Stormwater Site Plan

East Town Crossing
2902 E Pioneer
Puyallup, WA 98372
2230723.10

November 2023

EXISTING CONDITIONS MAP	A-2
EAST TOWN CROSSING

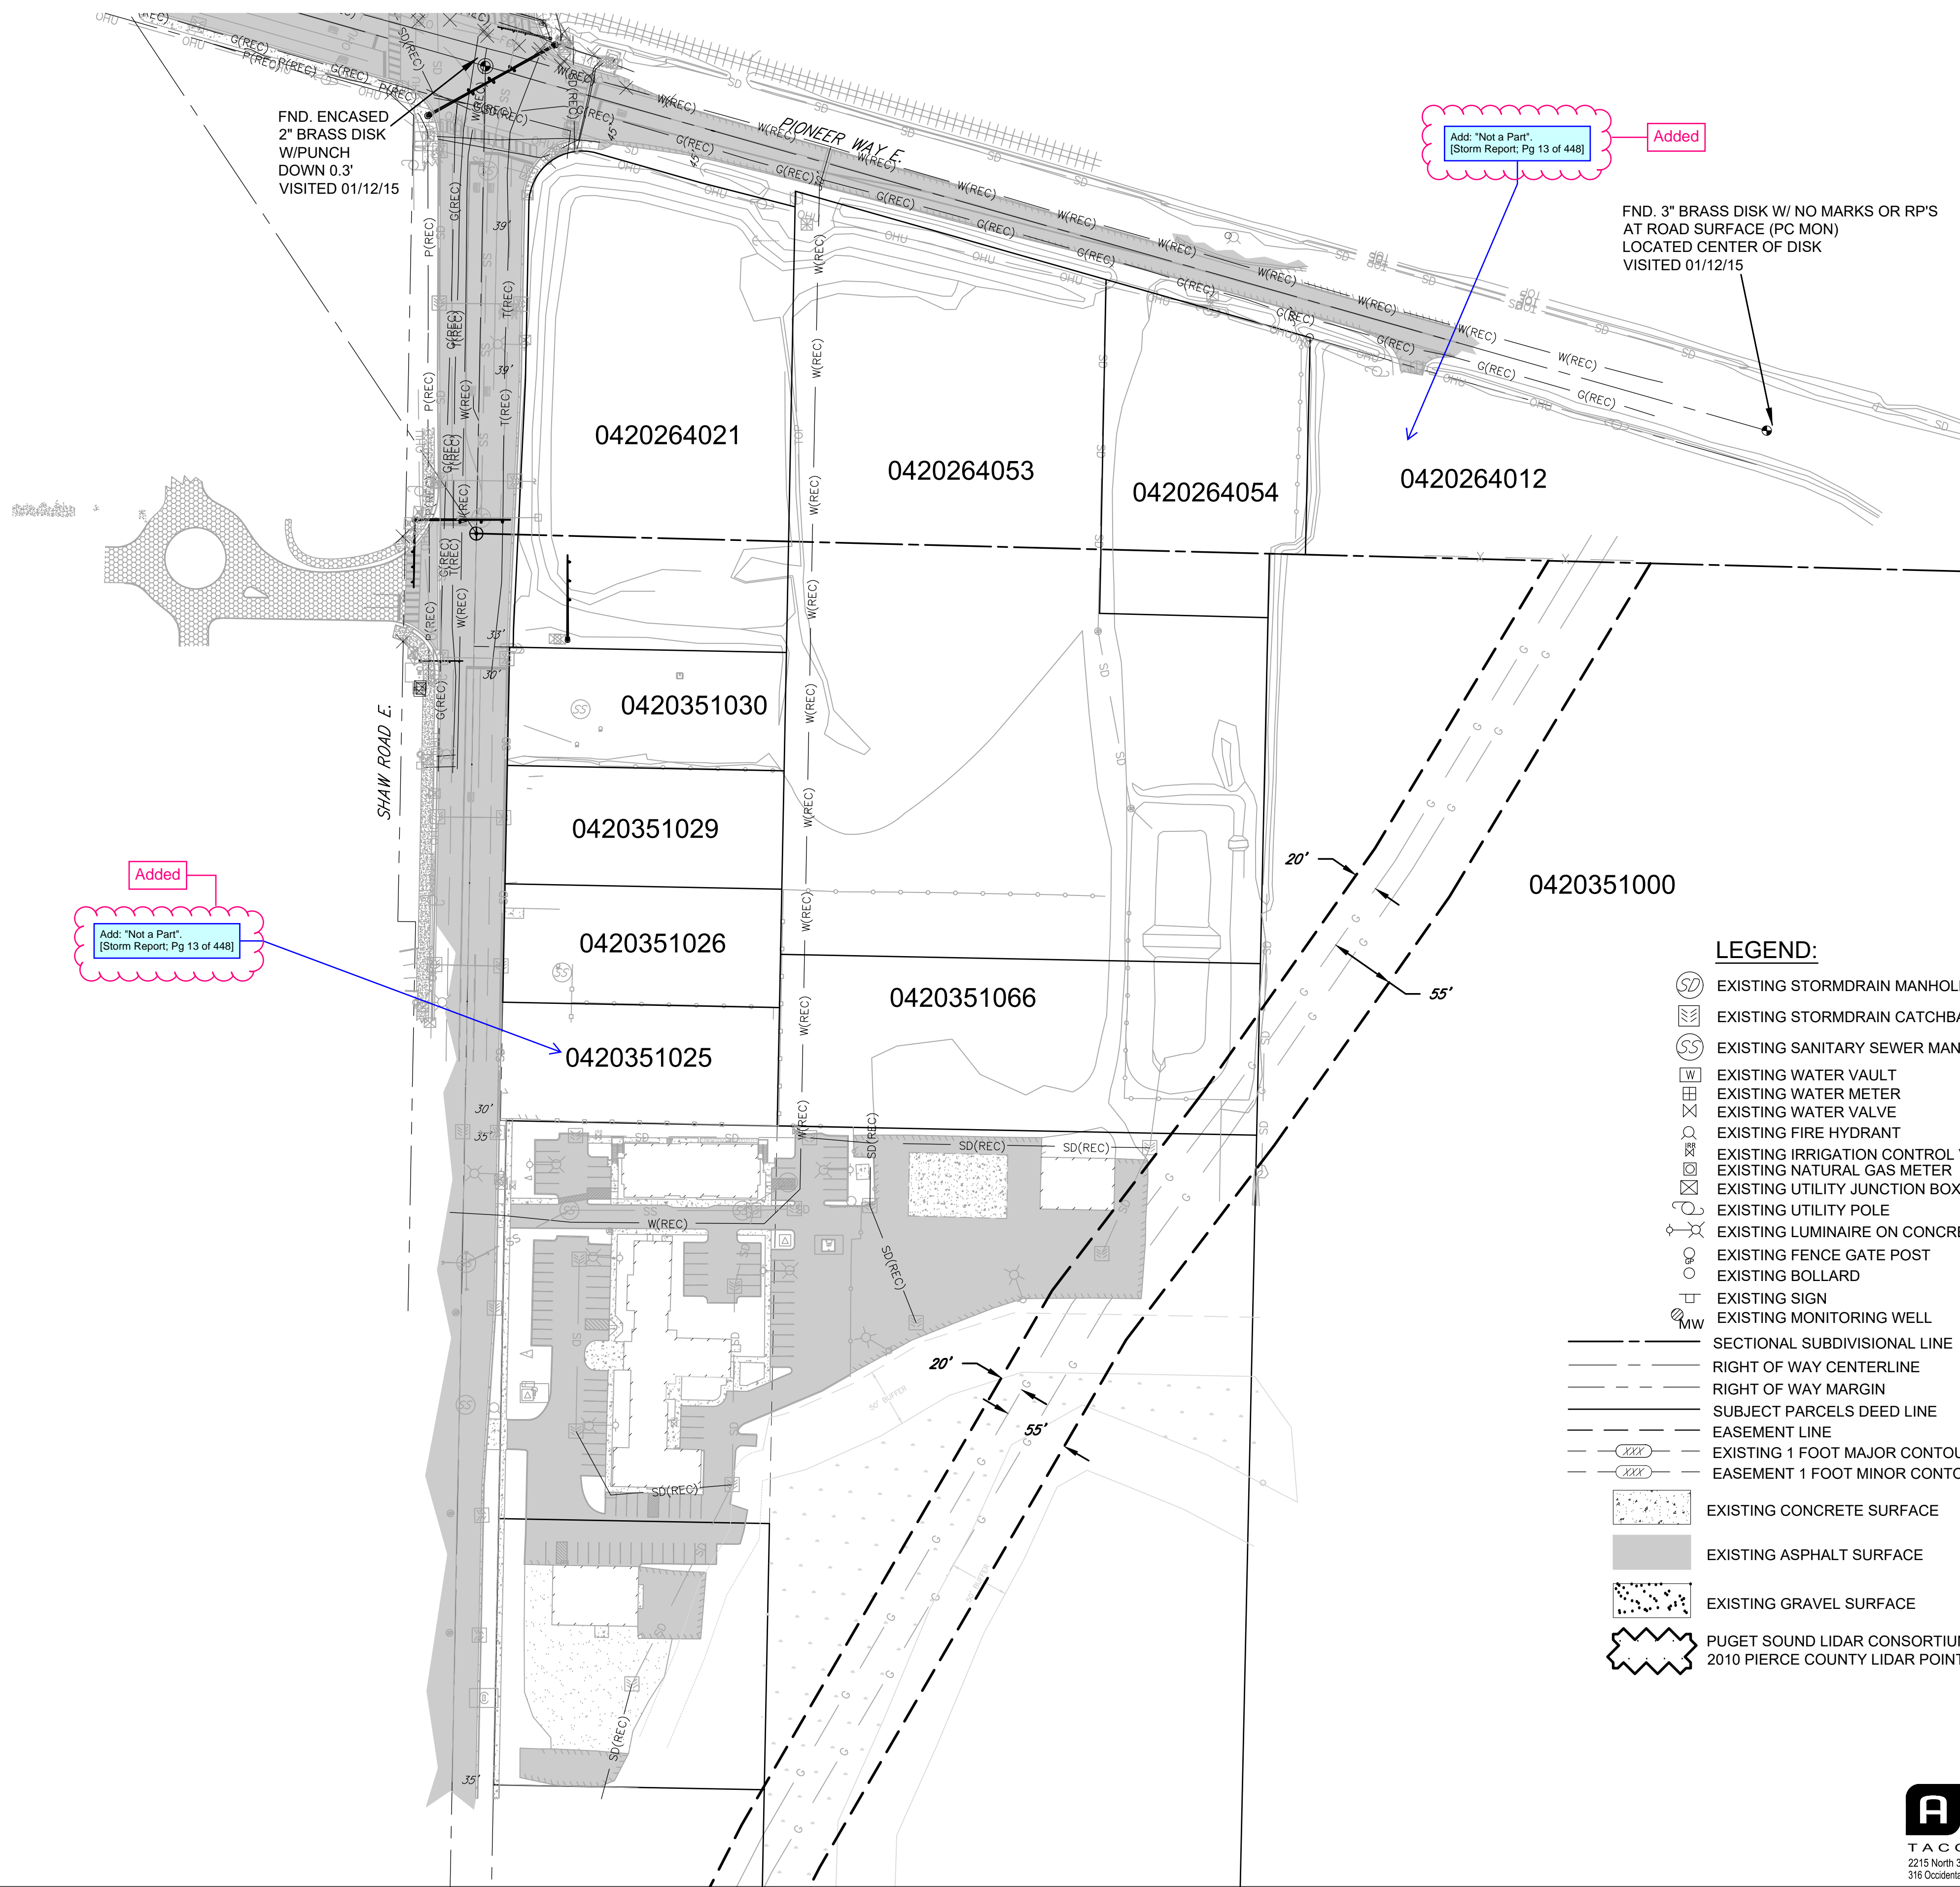
Add: "Not a Part". [Storm Report: Pg 13 of 448]

Add: "Not a Part". [Storm Report: Pg 13 of 448]

Add

DEVELOPED CONDITIONS MAP
EAST TOWN CROSSING

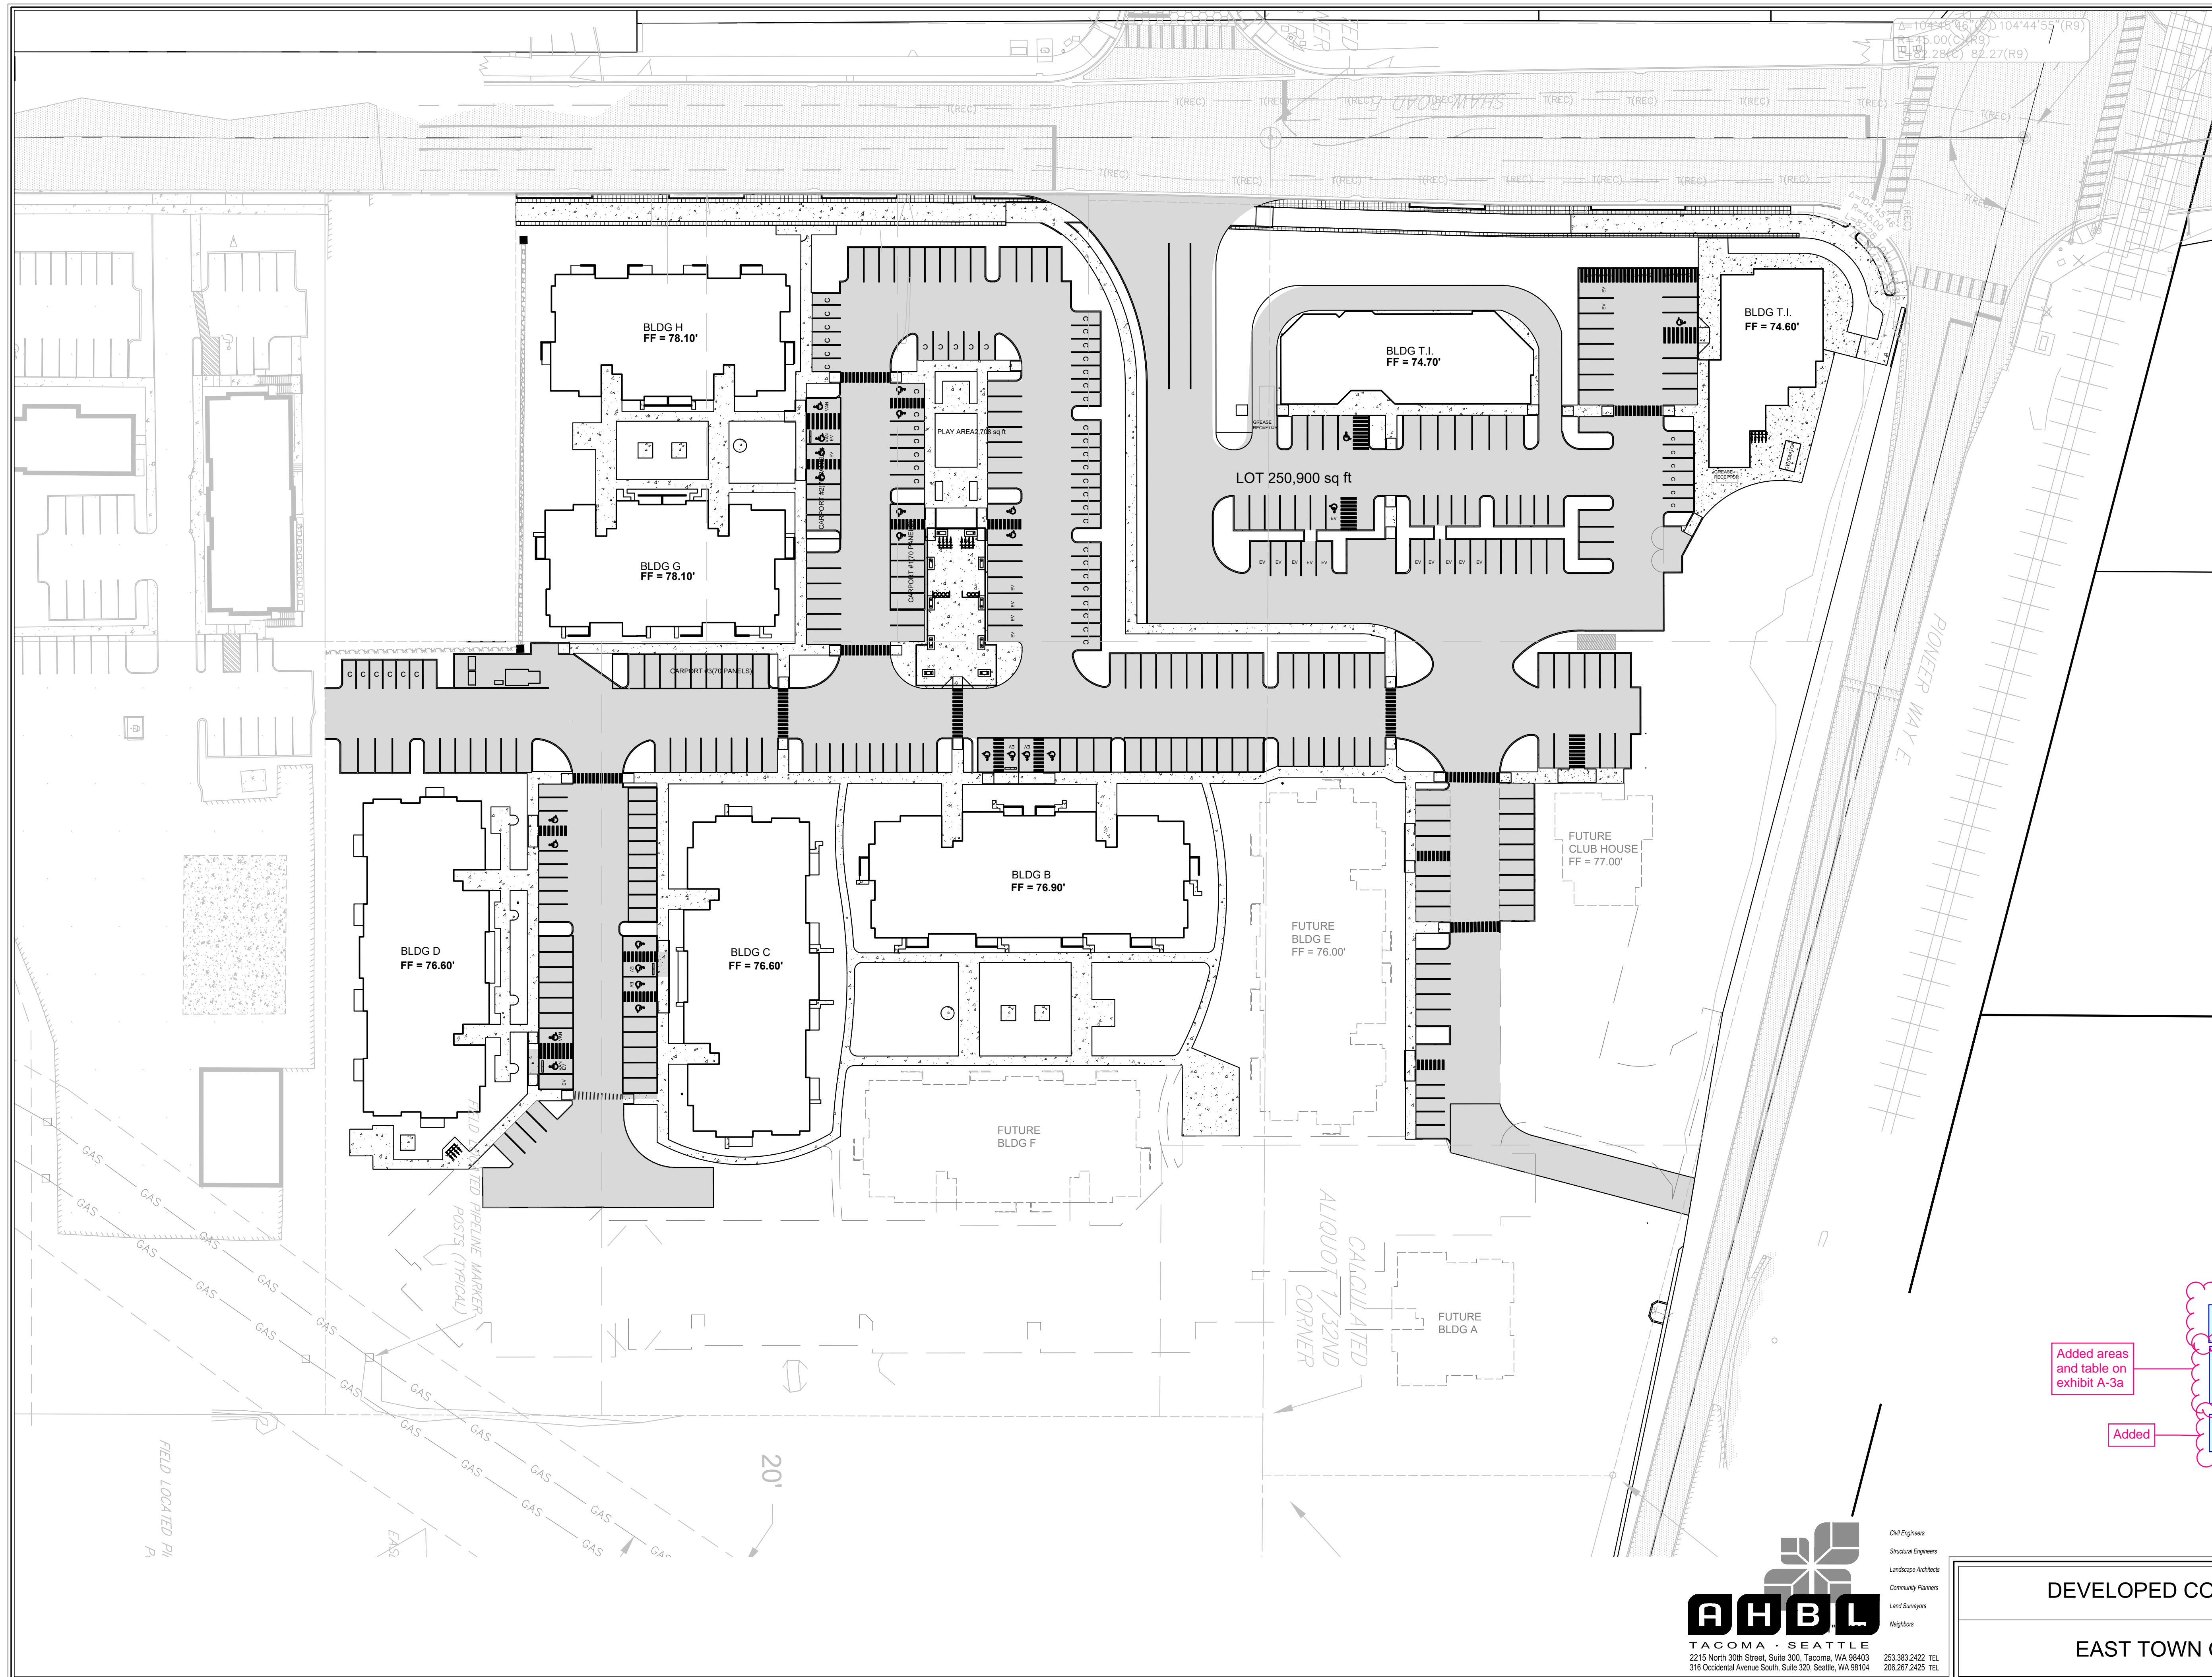
Identify/Delinate subbasins (Upper, Lower, Bypass) used in the modeling. [Storm Report, Pg 14 of 448]

Please provide a surface area breakdown by phase and basin name. For example, PH1 MF Roof area = _____ sf (ac); PH2 MF Roof area = _____ sf (ac); etc. Provide a total for each basin breakdown. Also, include the frontage bypass basins. [Storm Report, Pg 14 of 448]

Identified on exhibit A-3a

Added areas and table on exhibit A-3a

Added

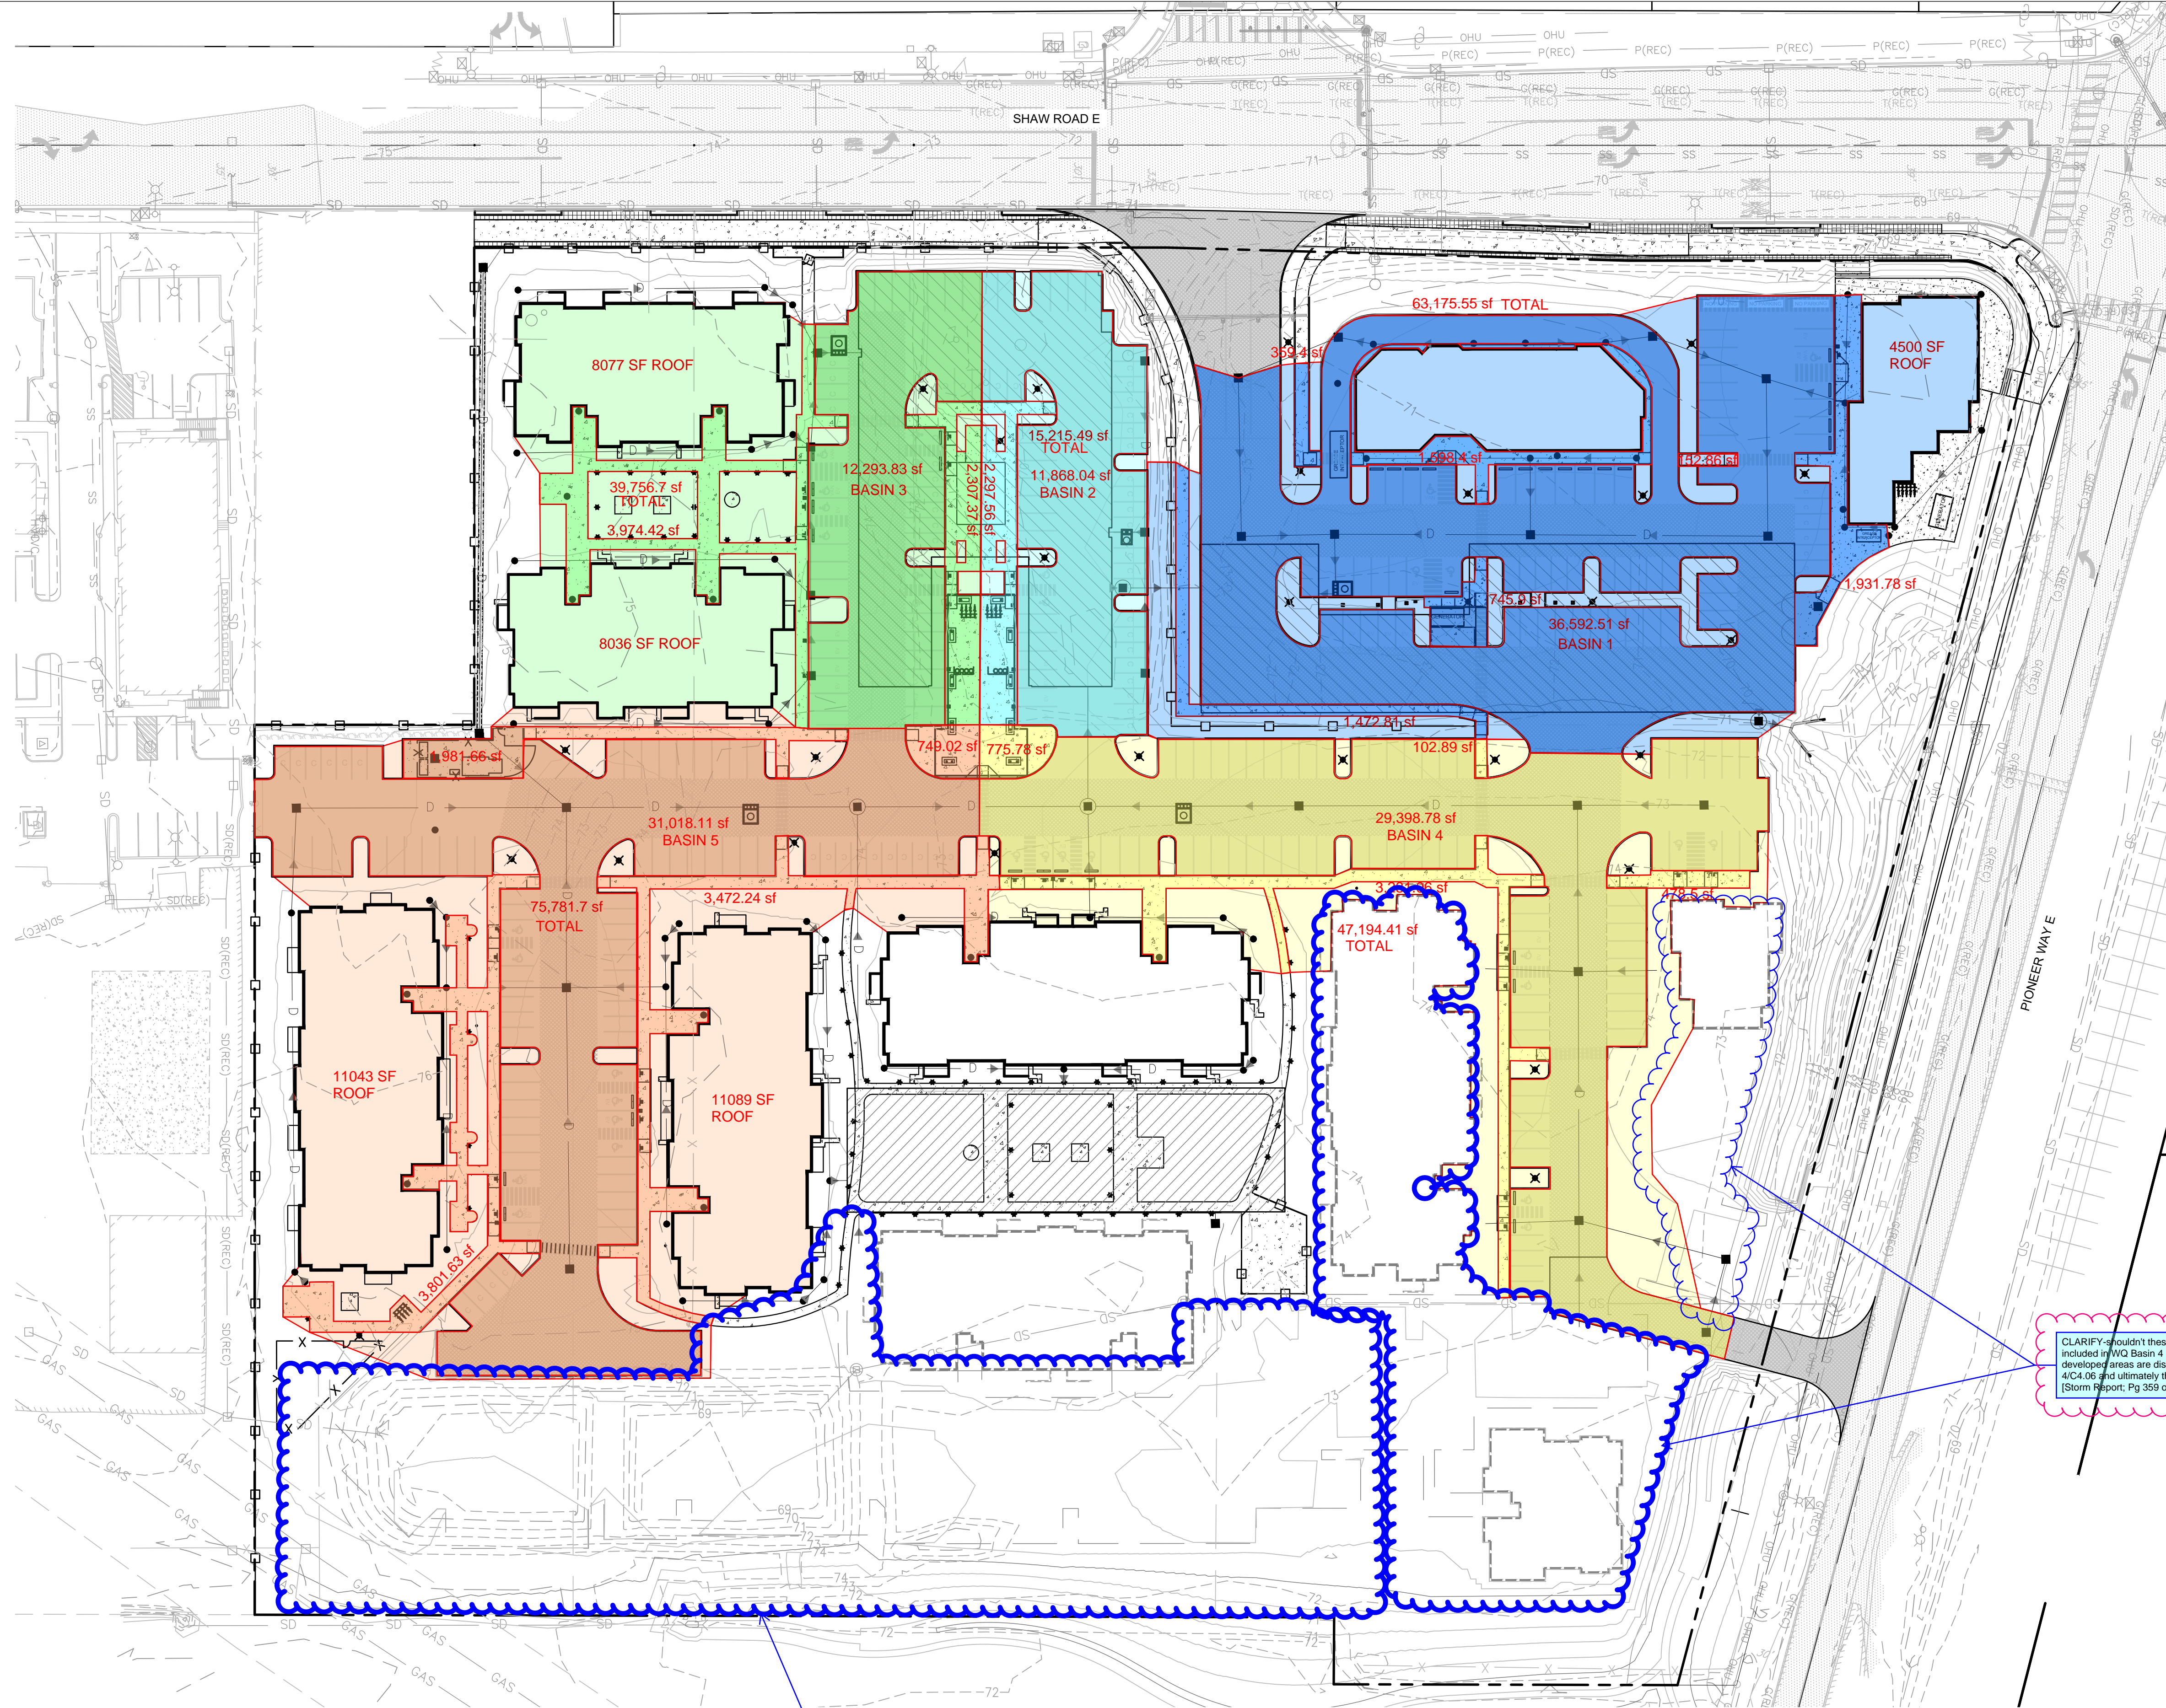
CLARIFY—shouldn't these PH2 areas be included in WQ Basin 4 since the future developed areas are discharging to Profile 4/C4.06 and ultimately the WQ4 Biopod? (Storm Report: Pg 359 of 448)
